International Aero Engines

V2500-A1 PROPULSION SYSTEMS SERVICE BULLETIN

This document transmits Revision 1 to Service Bulletin EV2500-71-0110

ENGINE – PROVIDE REROUTED OIL TUBES FOR THE ACOC AND THE OIL TANK ASSEMBLY

Raft and Brackets - After Alteration
Figure 5

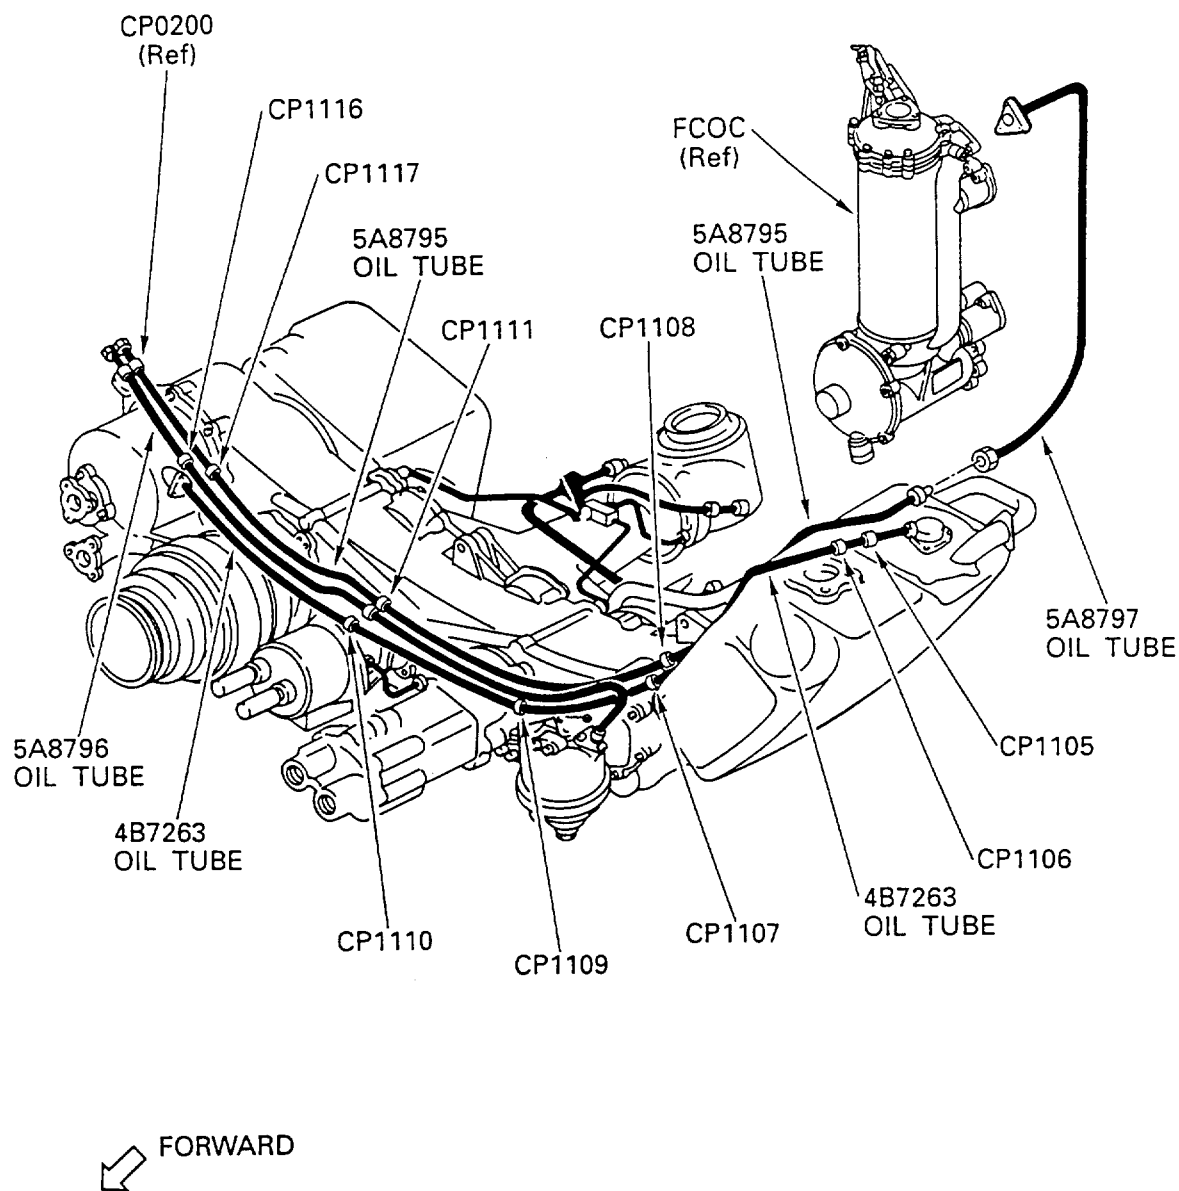
- (vii) The new clipping positions CP1113, CP1112 and CP1106 are introduced to hold the electrical harnesses (See Figure 7).
 - (viii) The existing brackets 740-5425-505 which is used to hold the electrical harnesses at CP0846 is deleted (See Figure 3 and 5).

- (ix) The new bracket 5W8398 is introduced to hold the electrical harnesses at CP1112 and CP1113 (See Figure 5).
 - (x) The new bracket 5W8399 is introduced to hold the oil tubes at CP1116 and CP1117 (See Figure 4, Sheet 3).

- (c) The existing catalog sequence numbers of the raft assembly which is used to secure the case drain filter are changed to the new catalog sequence numbers (See Figures 3 and 5).

- (1) Install the Raft Assembly and the clipping Bracket as follows (Refer to Figure 5):
 - (a) Install 740-5622-501 Attachment Angle and 740-5923-501 Packing Piece at the holes 56 and 57 on the Flange FA with the two NAS7204U6 Screws, SP155E Washers and NAS1291C4M Nuts or H42-4 Nuts.

NOTE: It is not necessary to lubricate the bolt threads with the nuts as these nuts have a dry film lubricant on their threads.
 - (b) Install 740-5620-503 Attachment Angle at the hole 88 and 90 on the Flange FA1 with the two 4W0164 Bolts and 4W0002 Nuts.

- (c) Torque the nuts installed in step (a) and step (b) to 85 to 105 lbfin. (10 to 12 Nm).
 - (d) Attach 740-5601-507 Raft Assembly and 5W8398 Bracket to the Attachment Angles, with the two 4W0162 Bolts and the two 4W0164 Bolts. Torque the bolts to 85 to 105 lbfin. (10 to 12 Nm).

Pressure Oil Tubes and Tube Clipping Details - After Alteration
Figure 6, Sheet 1 of 4

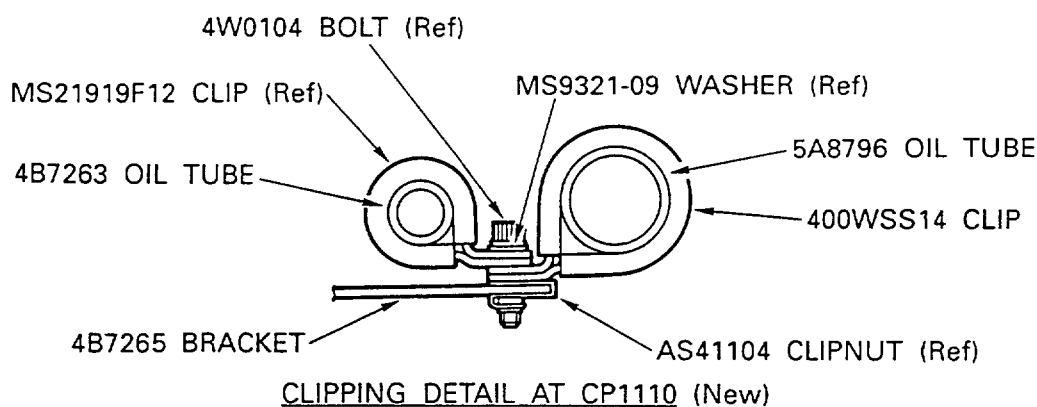
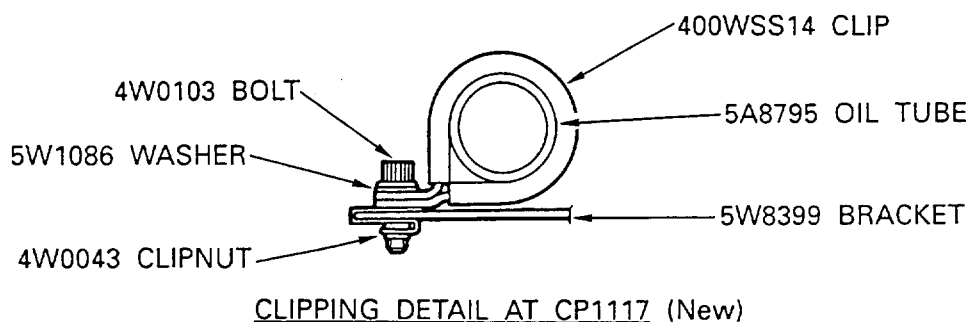
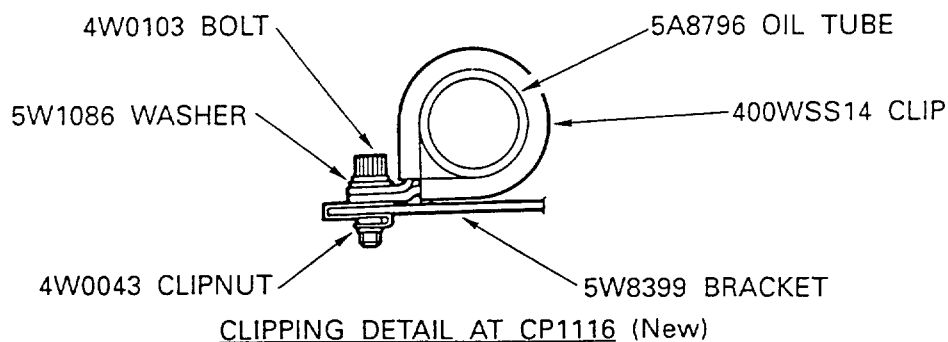
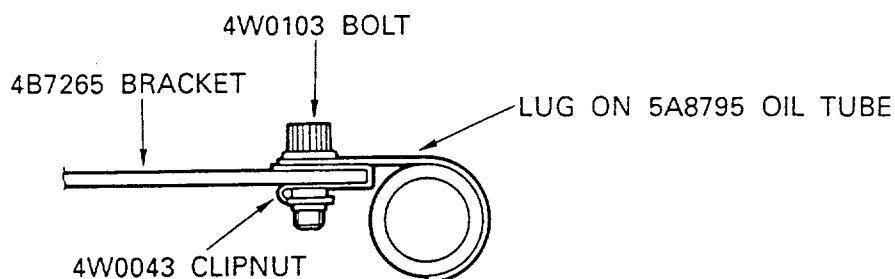
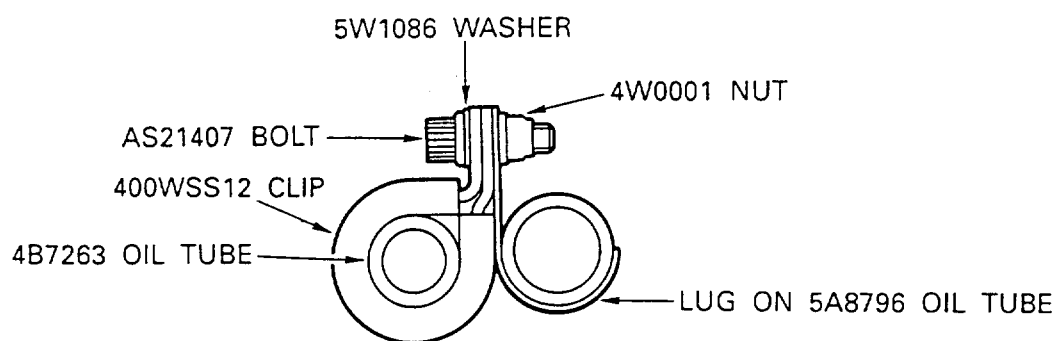
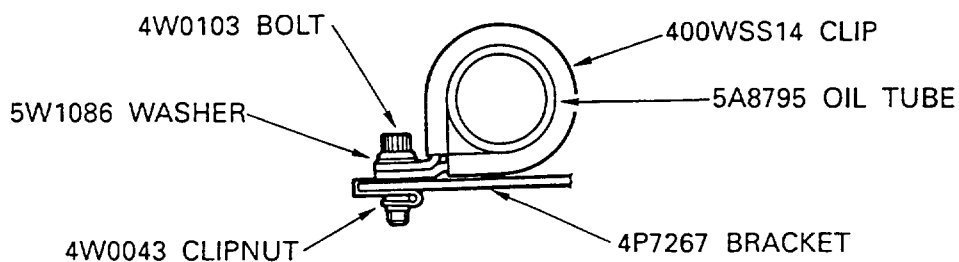
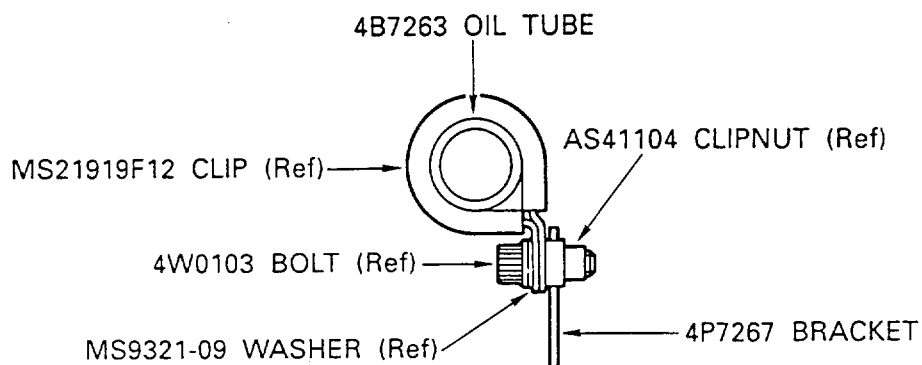
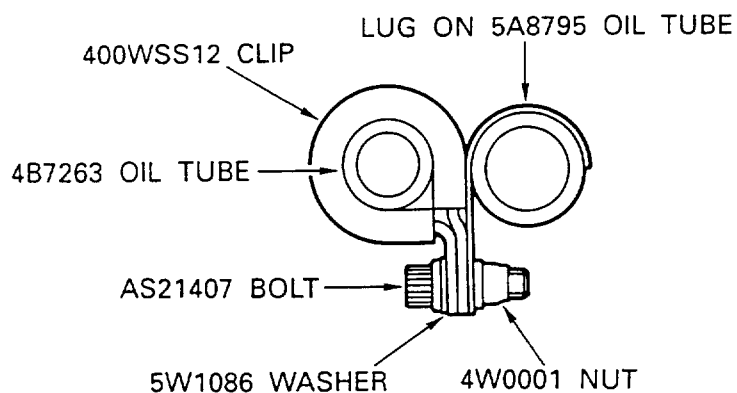
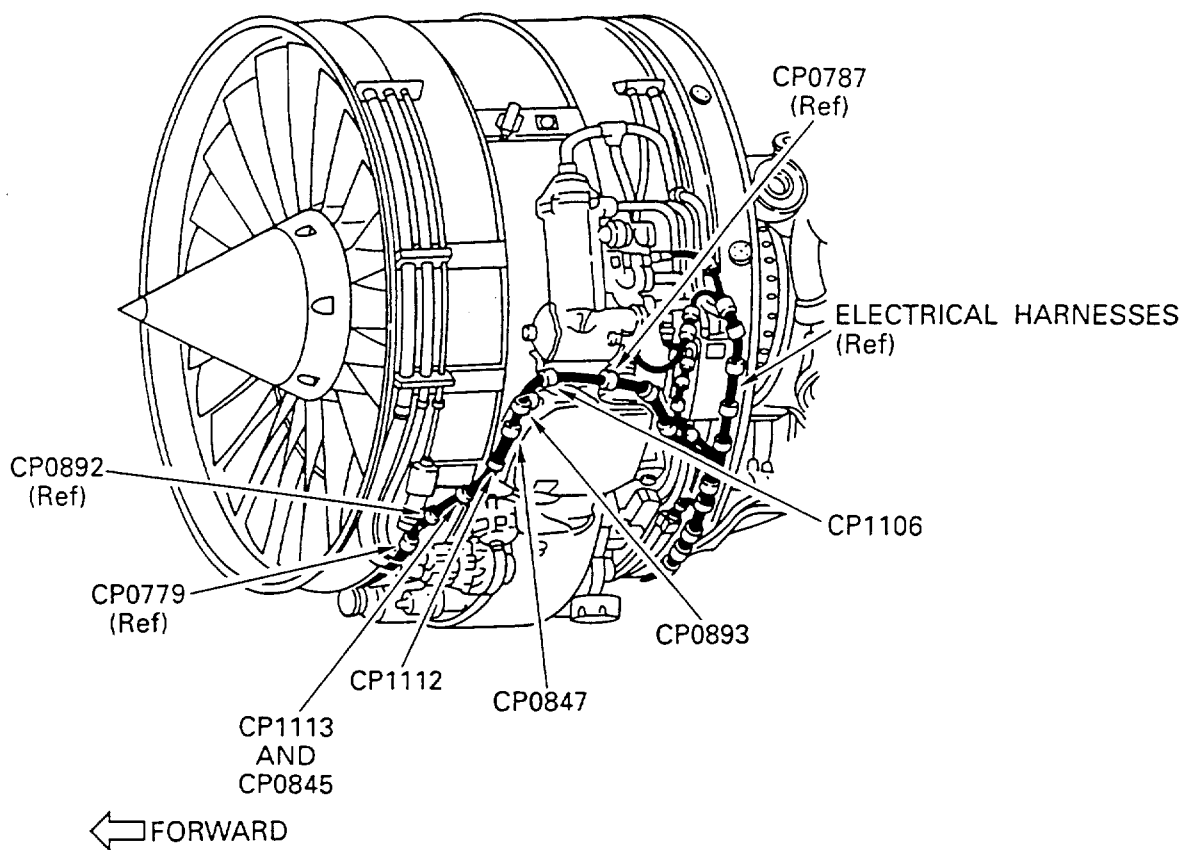
(a) New oil tubes 5A8796, 5A8795, 5A8797 and 4B7263 are introduced in lieu of the existing oil tubes 5A8786, 5A9081, 5A8770 and 4B7200 (See Figures 1 and 6).

- (ii) The new clipping positions CP1116, CP1117, CP1110, CP1111, CP1109, CP1108, CP1107 and CP1105 are introduced to hold the new oil tubes (See Figure 6).

- (3) Install the Oil Tube (Oil Tank Breather Tube) to the External Gearbox as follows (Refer to Figure 6):
 - (a) Attach the two MS21919F12 Clips and 400WSS12 Clip on to 4B7263 Oil Tube (Oil Tank Breather Tube).

- (4) Install the Oil Tubes (ACOC to FCOC Oil Tubes and ACOC Oil Supply Tube) as follows (Refer to Figure 6):
 - (a) Put 5A8795 Oil Tube (ACOC to FCOC Oil Tube) to the External Gearbox.

Clipping Details of the Electrical Harnesses - After Alteration
Figure 7, Sheet 1 of 3

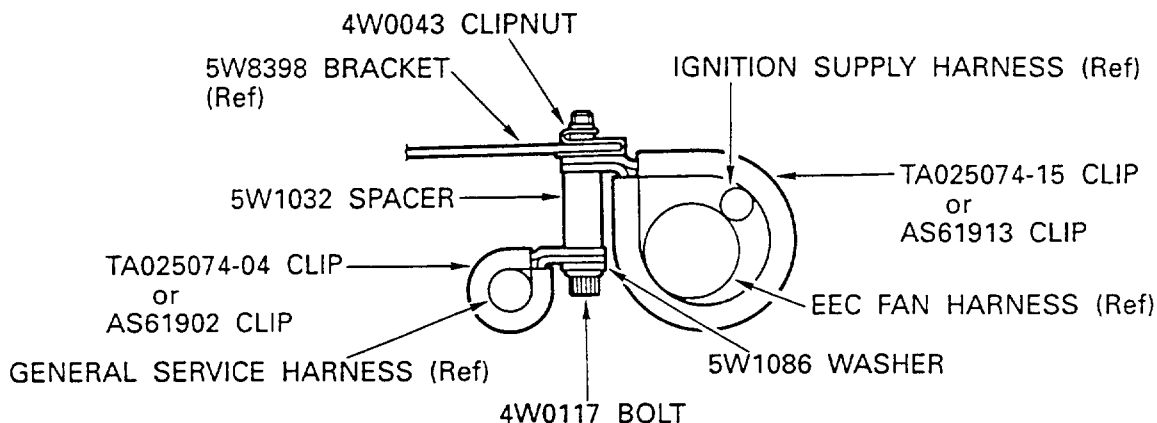
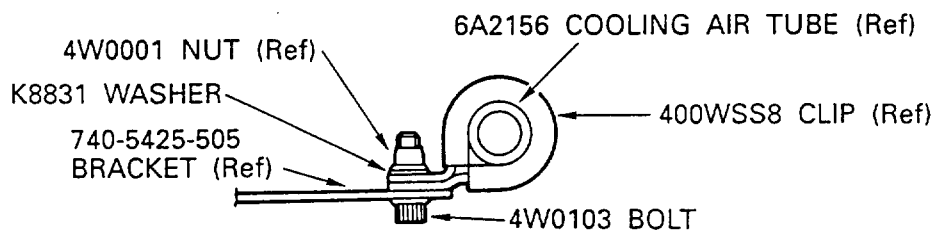
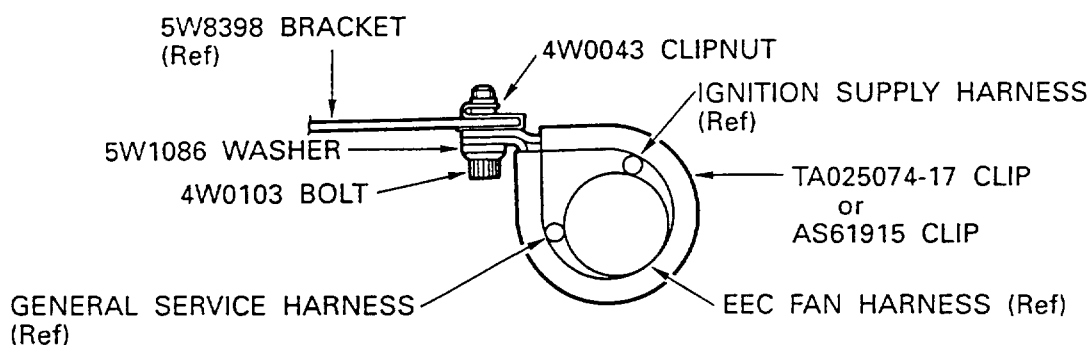
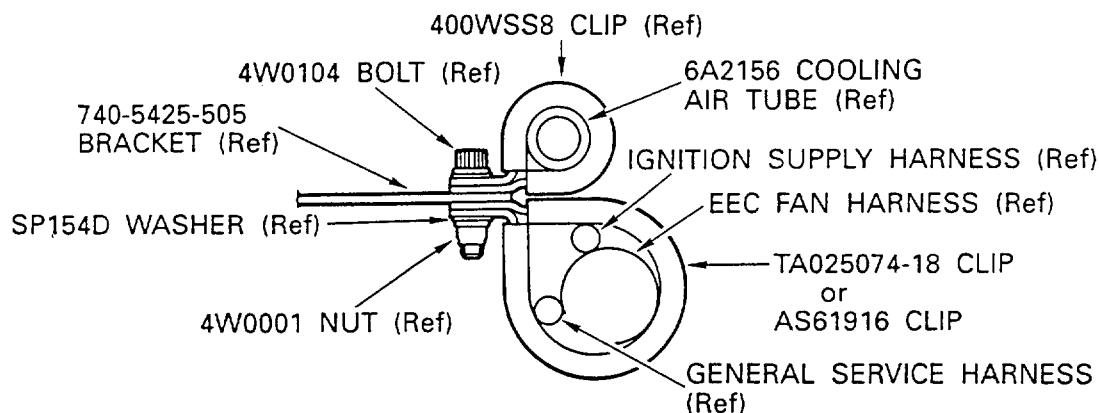
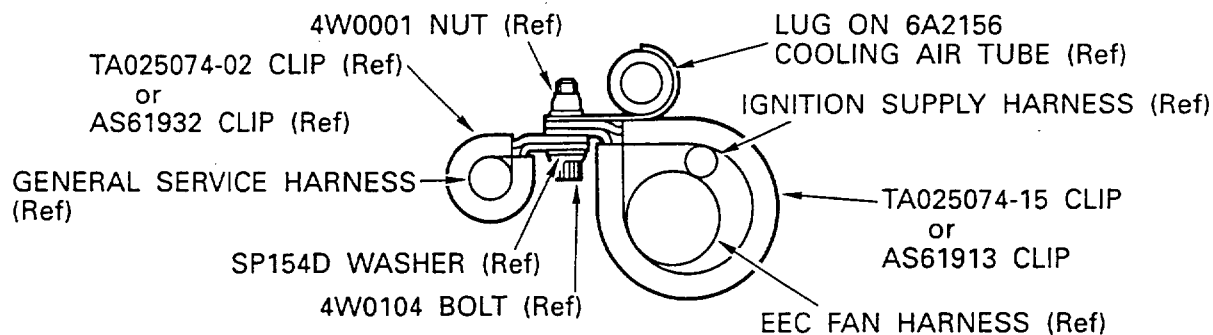
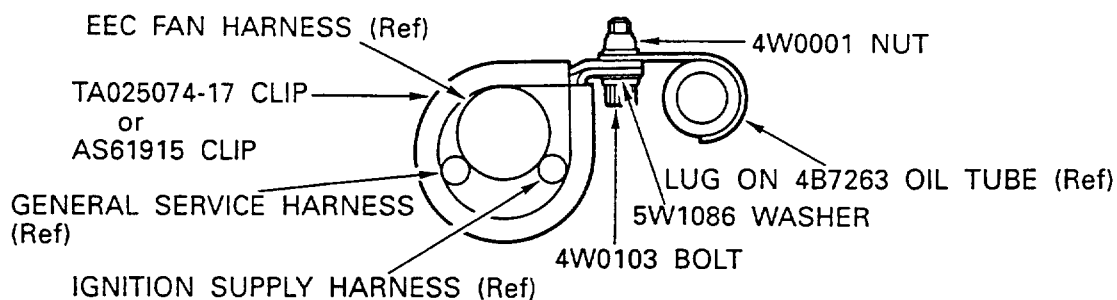
- (v) The existing clipping positions CP0846, CP1019, CP1020 and CP0786 which are used to hold the electrical harnesses are deleted (See Figure 2).
 - (vi) The existing clipping positions CP0845, CP0847 and CP0893 which are used to hold the electrical harnesses are changed to the new clipping configurations (See Figures 2 and 7).

- (5) Install the electrical harnesses to the LP Compressor/Intermediate Case Module as follows (Refer to Figure 7):
- (a) Install the EEC Fan Harness, the General Services Harness and the Ignition Supply Harness to the LP Compressor/Intermediate Case Module by use of approved procedures in the Engine Manual, 72-00-32, Installation, TASK 72-00-32-420-004 (Refer to 1.K.(2)).

- (b) At the bottom and left hand side of the LP Compressor/Intermediate Case Module, assemble the following clipping positions (Refer to Figure 7):
 - (i) At CP1113, attach TA025074-15 Clip or AS61913 Clip on to the EEC Fan Harness and the Ignition Supply Harness, and TA025074-04 Clip or AS61902 Clip on to the General Service Harness and install them to 5W8398 Bracket with 4W0117 Bolt, 5W1086 Washer, 5W1032 Spacer and 4W0043 Clipnut. Torque the bolt to 36 to 45 lbfin (4 to 5 Nm).

- (ii) At CP1112, attach TA025074-17 Clip or AS61915 Clip on to the EEC Fan Harness, the Ignition Supply Harness and the General Service Harness and install it to 5W8398, Bracket with 4W0103 Bolt, 5W1086 Washer and 4W0043 Clipnut. Torque the bolt to 36 to 45 lbfin (4 to 5 Nm).

- (iii) At CP0847 attach TA025074-18 Clip or AS61916 Clip on to the EEC Fan Harness, the Ignition Supply Harness and the General Service Harness and install it together with 400WSS8 Clip, on Cooling Air Tube to 740-5425-505 Bracket with 4W0104 Bolt, SP154D Washer and 4W0001 Nut. Torque the nut to 36 to 45 lbfin (4 to 5 Nm).

- (iv) At CP0893 attach TA025074-15 Clip or AS61913 Clip on to the EEC Fan Harness and the Ignition Supply Harness, and TA025074-02 Clip or AS61932 Clip, on to the General Service Harness and install them to the lug on 6A2156 Cooling Air Tube with 4W0104 Bolt, SP154D Washer and 4W0001 Nut. Torque the nut to 36 to 45 lbfin (4 to 5 Nm).
- (v) At CP1106 attach TA025074-17 Clip or AS61915 Clip, on to the EEC Fan Harness, the Ignition Supply Harness and the General service Harness and install it to the lug on 4B7263 Oil Tube (Oil Tank Breather Tube) with 4W0103 Bolt, 5W1086 Washer and 4W0001 Nut. Torque the nut to 36 to 45 lbfin (4 to 5 Nm).
